**Verified Carbon
Standard**

100 MW SOLAR PROJECT IN BHADLA IN RAJASTHAN.

Report ID	VKU.VER.199.24_VCS_1842
Project title	100 MW SOLAR PROJECT IN BHADLA IN RAJASTHAN.
Project ID	1842
Verification period	01-September-2021 to 31-March-2023 (inclusive of start and end dates) ¹
Original date of issue	04-June-2024
Most recent date of issue	08-January-2025
Version	04

Figure No.: Location of project as verified from Google Earth

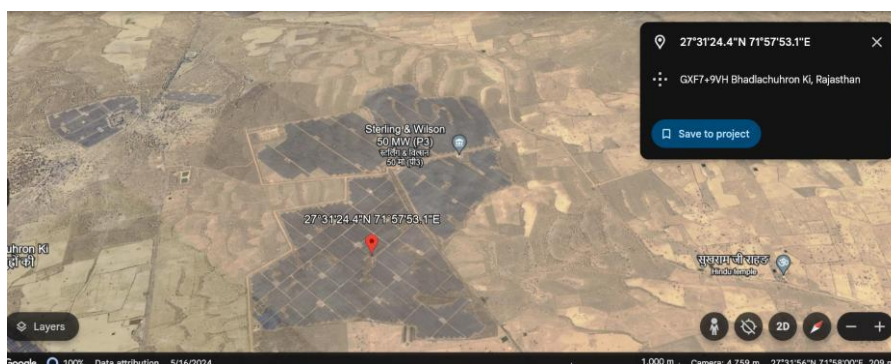
- 8) The geo coordinates of project location are incorrect, it does not represent the Solar PV Plant site.

8. PP has updated the project coordinate in the revised MR version 02 dated 23-July-2024. The updated geo-coordinates have been verified by assessment team with the help of google earth software. The coordinates provide correct information of project location and solar plant. **Hence, accepted by assessment team and closed.**
9. PP has clarified that “the project was only listed on GS, but the proponent discontinued it and did not proceed with registration. However, PP has not provided any supporting document to verify the claim. **(Open)**

VVB Assessment and Conclusion: The deviation in the geo-coordinates have been assessed by the assessment team during on-site visit of project activity with the help of GPS Map camera/33/ and found to be appropriate in terms of actual scenario of project implementation. Moreover, the geo-coordinates were also verified with the help of Google earth software/34/. Assessment team confirms that the deviation in project location geo-coordinates has no impact on the project baseline, additionality as there is no impact on the IRR of the project.

- a. Change in geocoordinates of project location: The geo coordinates mentioned in the current MR are consistent with the current project location and found to be correct as verified from Google earth software. The same has been verified during onsite assessment using GPS map camera.
- b. Change in PV module specification: There was an error in the PV module power output mentioned in the registered PD and previous monitoring reports, the corrected PV module specification is now provided in the current MP. The specifications are consistent with the onsite observation by assessment team.
- c. Change in inverter manufacturer name: The previously mentioned inverter manufacturer did not accurately represent the actual inverter installed at the project location. PP has provided the corrected invertor model: ABB PVS980-58-2091 kVA.

Figure No 01.: Trends of PLF during 01-September-2021 to 31-March-2023

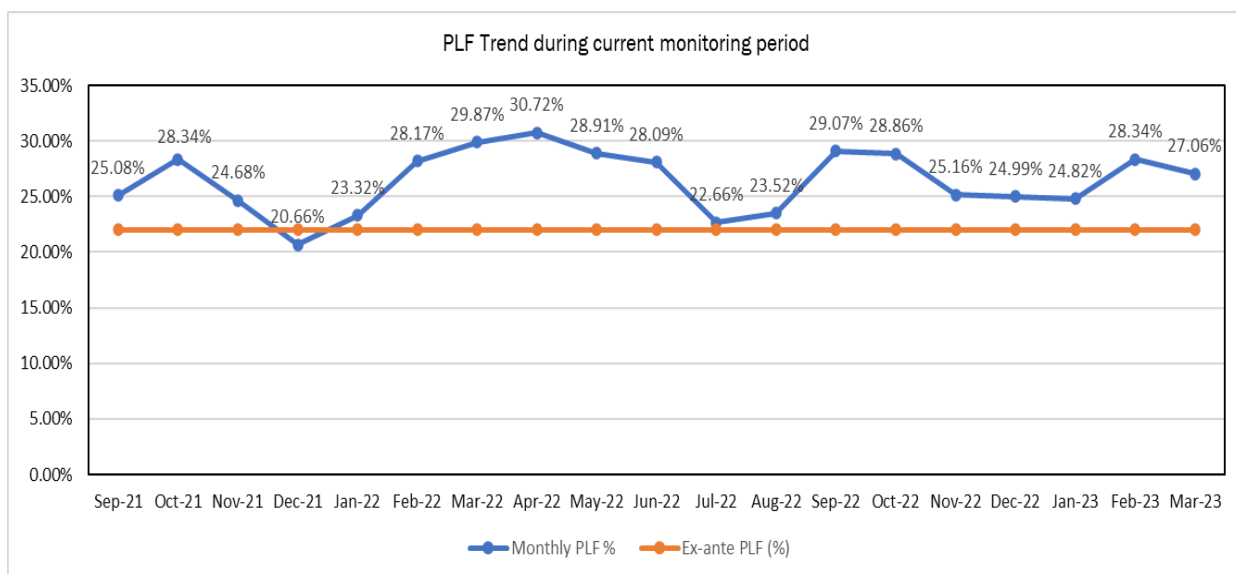
The month wise PLF achieved has been provided by the Project Proponent in ER sheet/02/ and the assessment team has verified the data and plotted the graph showing a the PLF trend during entire monitoring range and comparing it with the ex-ante PLF value as per the registered Joint Validation and Verification Report/03b/.

8. PP has clarified that increase in PLF is due to climatic variations beyond the control of the Project Proponent. The higher generation observed in few months is due to sunnier days in few months. PP has also provided PLF calculation sheet for the current monitoring period. **Hence, this is accepted and closed.**
